CLIMATE
ACTION
RESERVE

SUMMARY OF COMMENTS & RESPONSES DRAFT LIVESTOCK PROJECT PROTOCOL VERSION 4.0

4 sets of comments were received during the public comment period for the Climate Action Reserve (Reserve) draft Livestock Project Protocol Version 4.0. Staff from the Reserve summarize and provide responses to these comments below.

Figure 1. Monthly milk production rates (lb/head) compared against the annual average monthly production rates for each year (0% represents a monthly production rate equal to the average monthly production rate for that year) (National Agricultural Statistics Service).

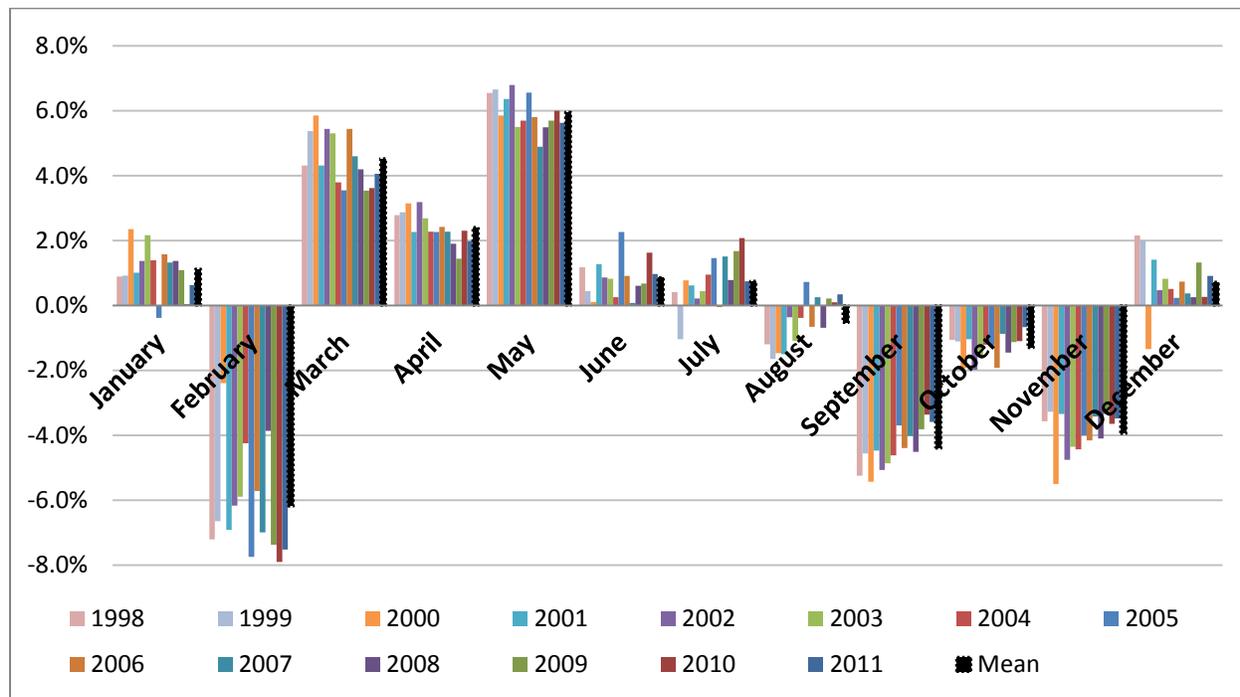
- b) Samples should be able to be taken in April or October or any other month that represents the average annual temperatures for the site. Why limit to August – October? To save costs we would like to be able to take samples ourselves whilst onsite for verifications.

- b) The Reserve identified August through November (changed from October in the draft) to be the months with historically below-average milk production, and thus the most conservative time for B_0 sampling and analysis. Milk production is a useful indicator for increases or decreases in the B_0 value over time. Periods of higher milk production tend to coincide with periods where the B_0 value of the manure is also higher, and vice versa. To determine the most conservative time of year for the sampling and analysis procedure, the Reserve consulted the National Agricultural Statistics Service data on national milk production (in lbs/head) for each month for the years 1998-2011. The milk production for each month was compared to the average monthly milk production for that year, highlighting monthly trends in milk production and controlling for the trend of increased milk production year-over-year. There was a consistent monthly pattern of milk production for every year during this time period (see Figure 1 below).
